Japan' position and proposal on draft of OBD-gtr

**Ministry of the Environment(MOE), Japan
&
Ministry of Land, Infrastructure,
Transport and Tourism (MLIT), Japan**

What is Fuel system monitoring?

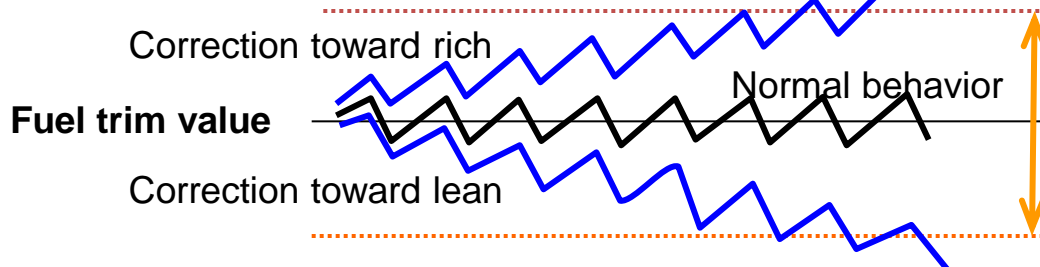
Japan believes that fuel system monitoring is significant issue and this monitoring should be included into gtr

- Checking fuel system function according to whether fuel trim value is within a certain range defined by manufacture or not.
- It is allowed to apply a specific driving mode for diagnosis.

Monitoring based on a logic if fuel system is normal and A/F F/B-control works stably, fuel trim value must be in this range.
